MISSISSIPPI RIVER - GULF OUTLET  
LOUISIANA

DESIGN MEMORANDUM NO. 1-B

CHANNELS

COMMENTS ON DESIGN MEMORANDUM INCLOSED WITH LETTER, LMNGY,  
DATED 15 SEPTEMBER 1958, SUBJECT, "DESIGN MEMORANDUM NO. 1-B,  
CHANNELS, MISSISSIPPI RIVER - GULF OUTLET"

**PLAN, PROFILE AND SOIL BORINGS**  
STA. 268+00 to 301+09.08 = 0+00 to STA. 75+00

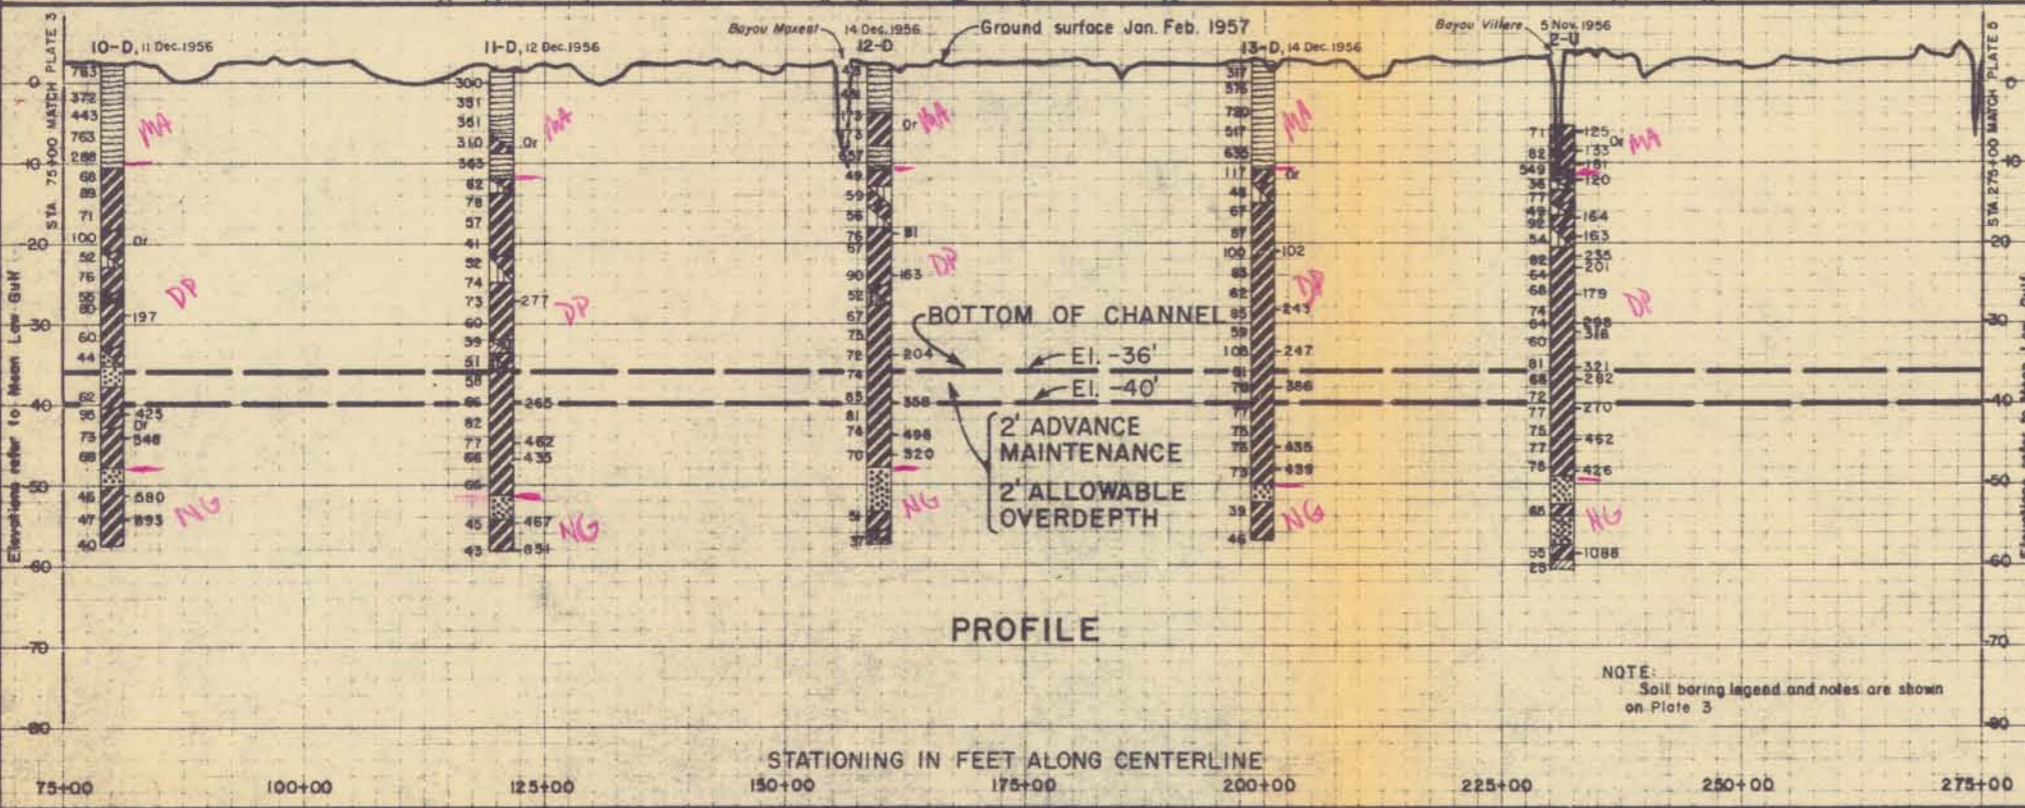
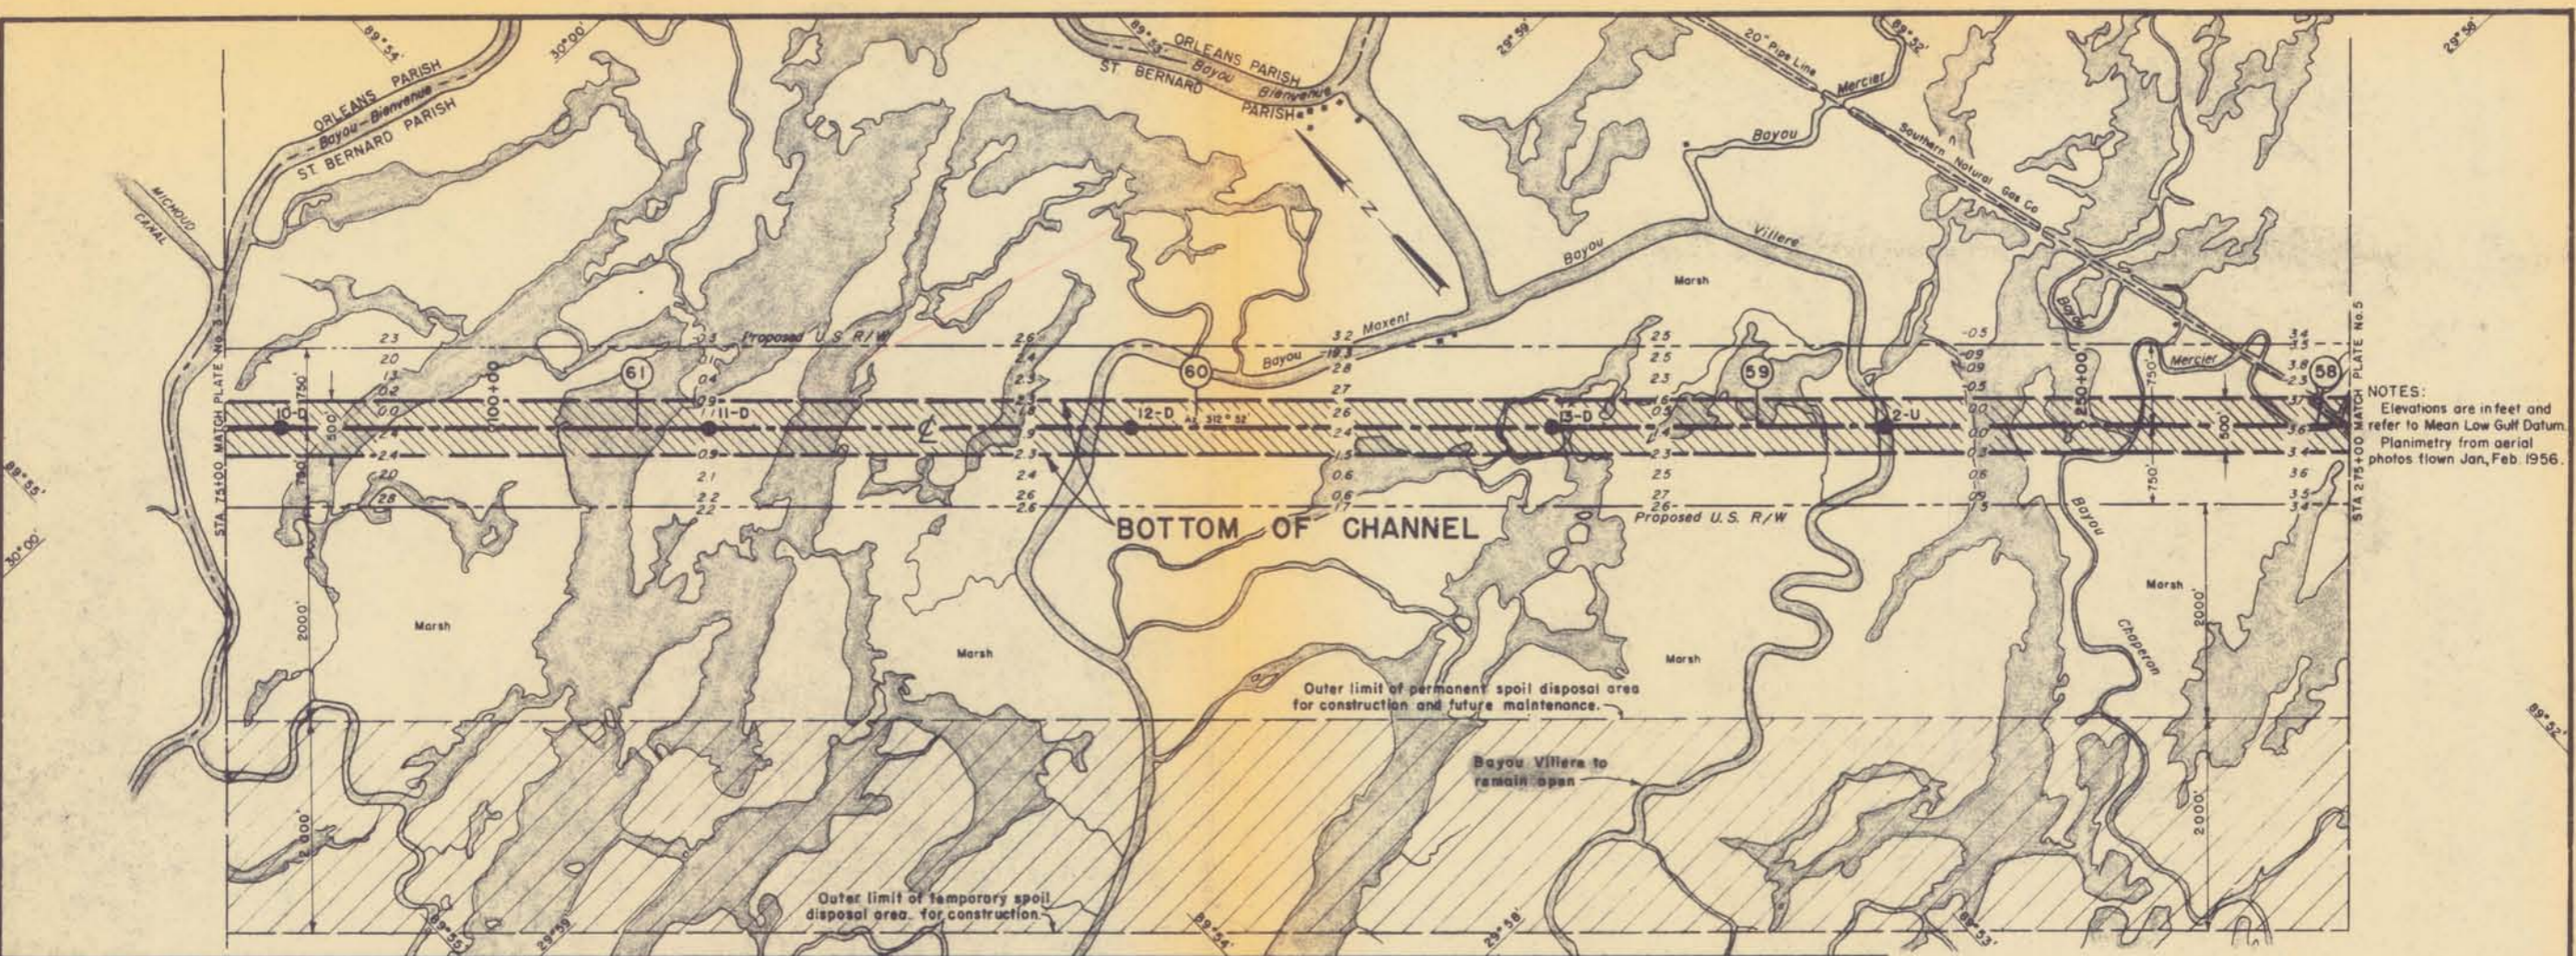
8. Plate 3. Shade water areas and show with appropriate gage symbol the location of Highway No. 47 Gage.

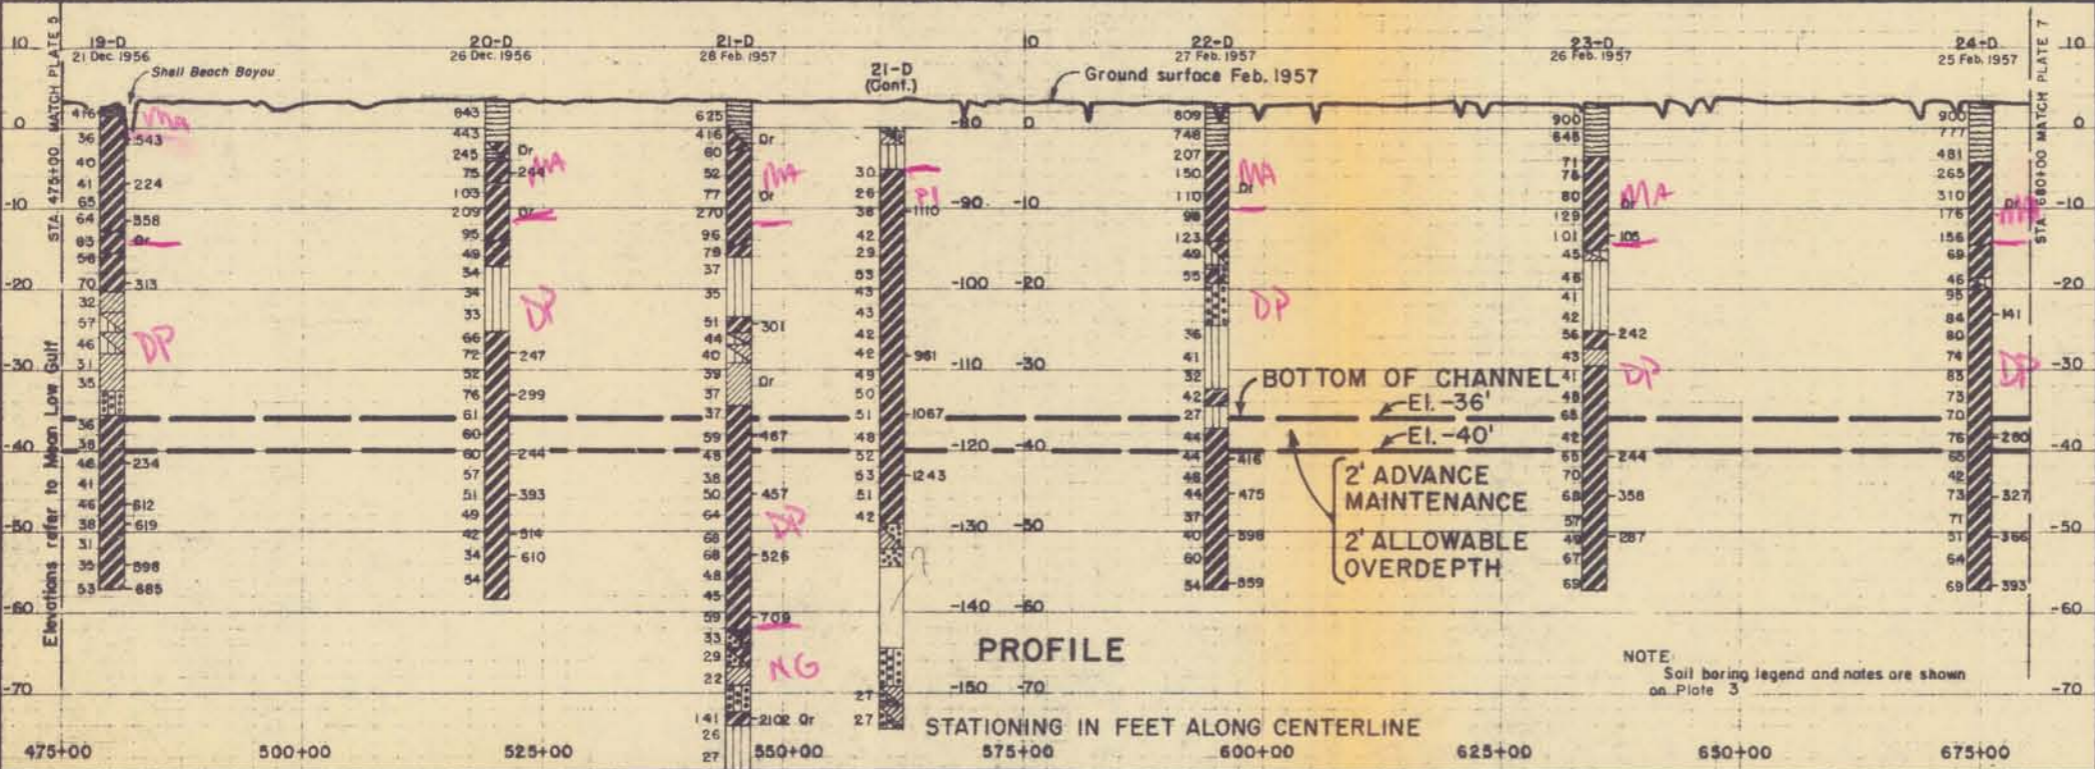
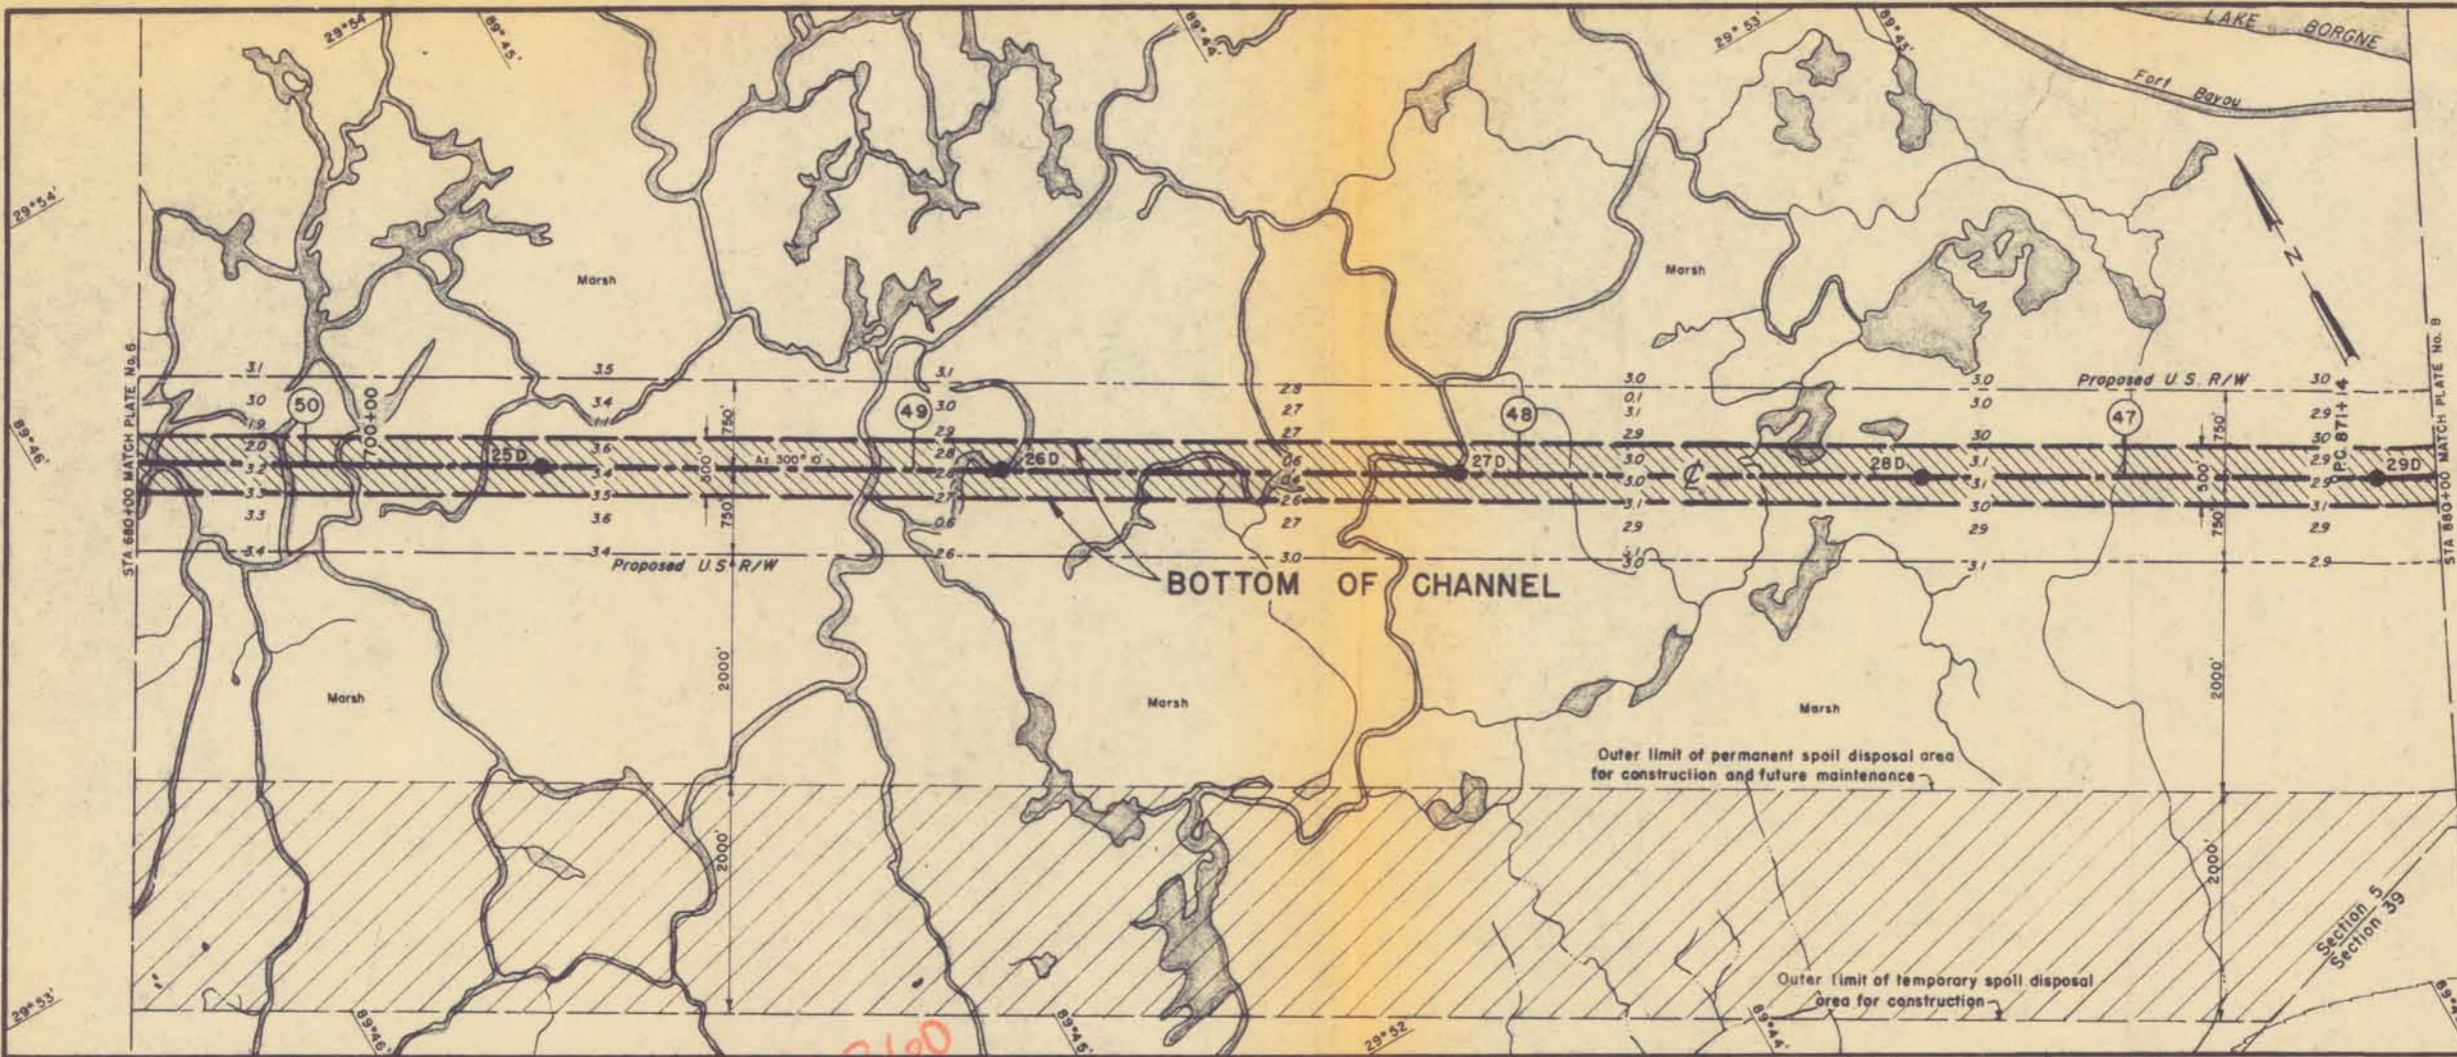
9. Plate 6. The stratum at elevation -140 MLG in boring 21-D should be classified.

**PLAN, PROFILE AND SOIL BORINGS**  
 STA. 880+00 TO STA. 1075+00

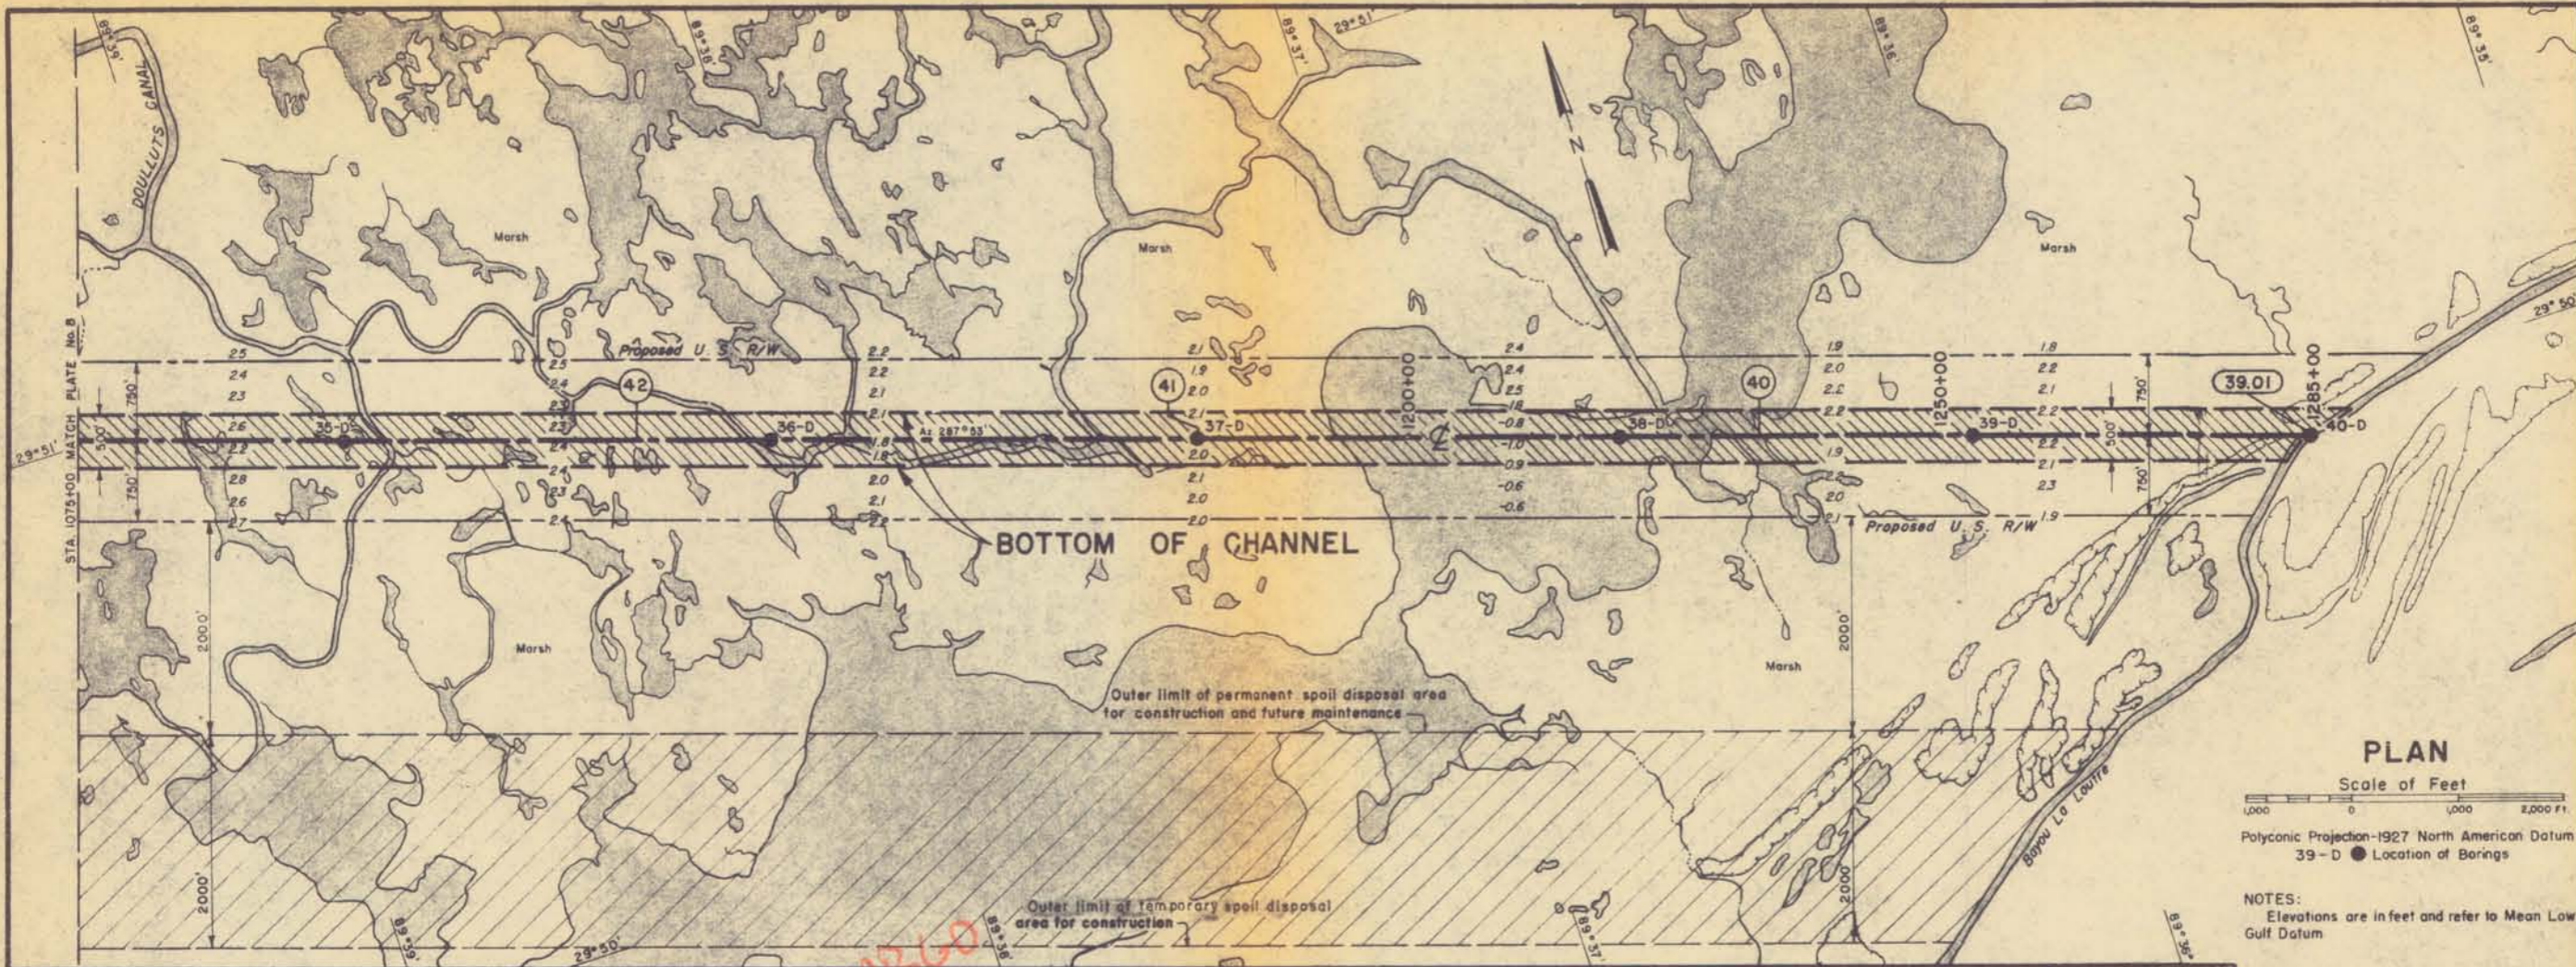
10. Plate 8. Shade water areas and show with appropriate gage symbol the location of Yscloskey Gage.
